**Merri-bek**  
City Council

# **Activity Centres Program Phase 2: Technical paper**

**October 2025**

Figure 8 – Map comparing Phase 2 catchment areas with Council recommended catchment areas for the Brunswick AC

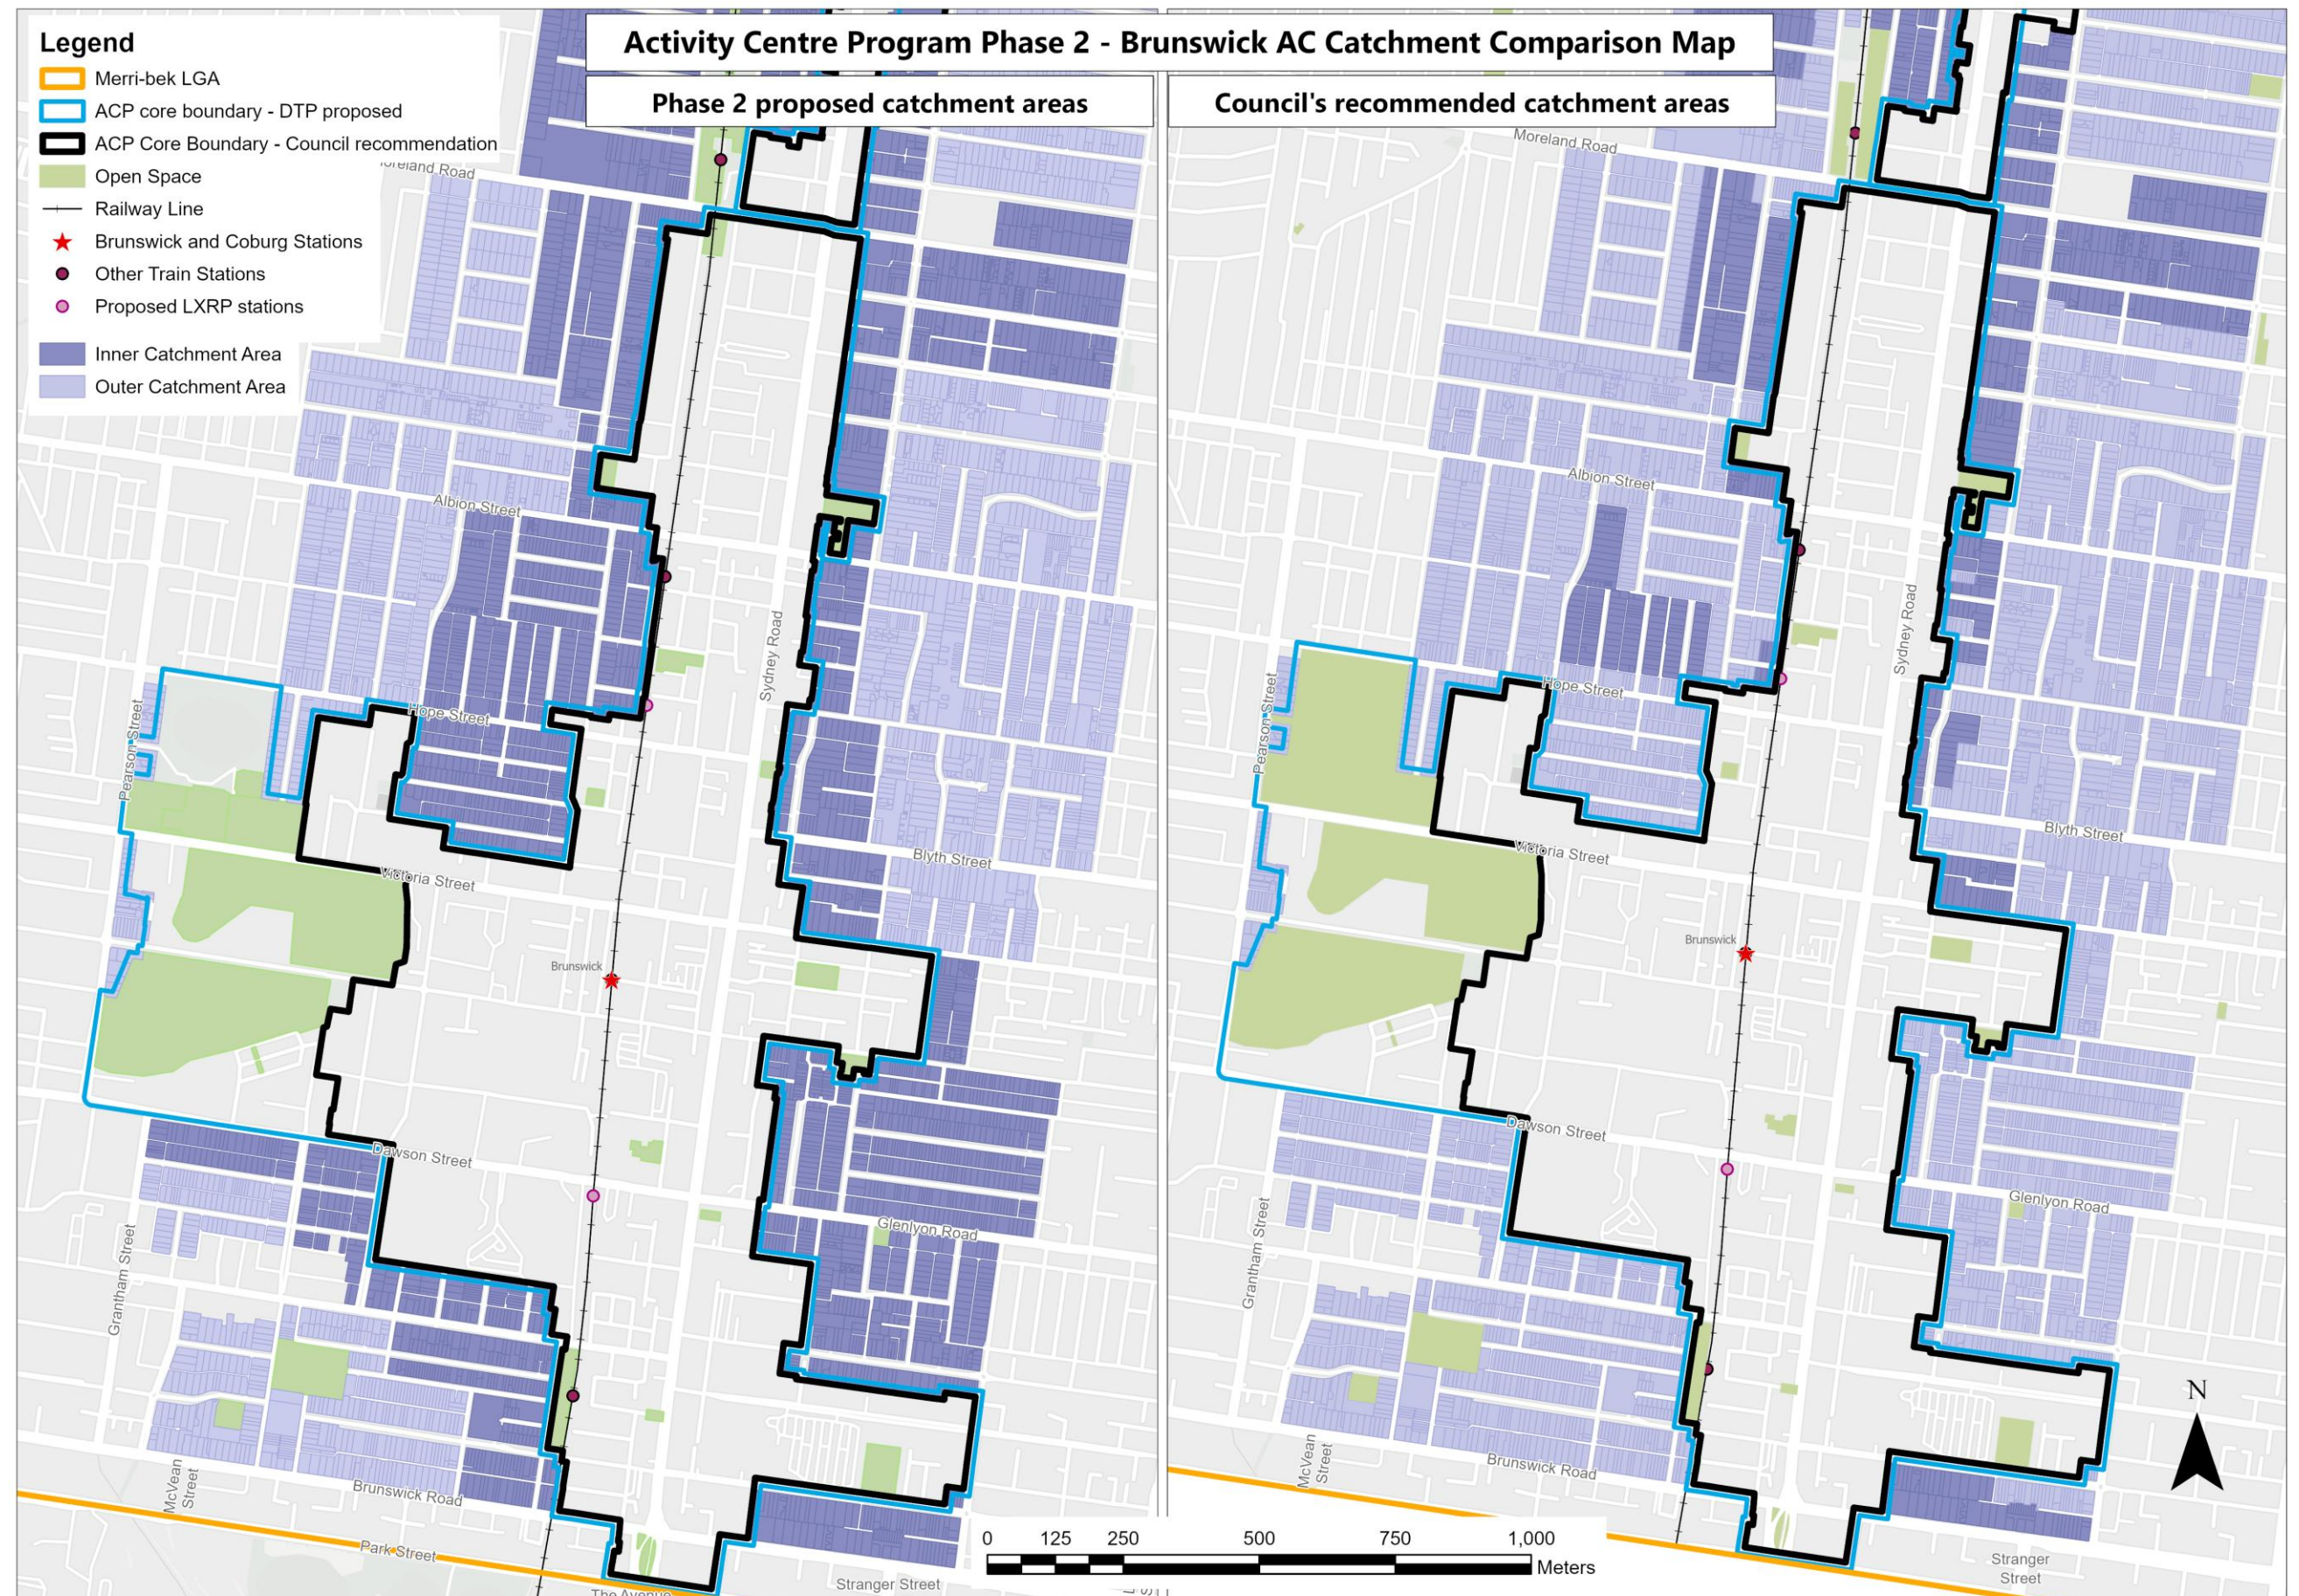
Council recommends changes to the inner and outer catchments, illustrated in Figure 7 & 8. These changes include:
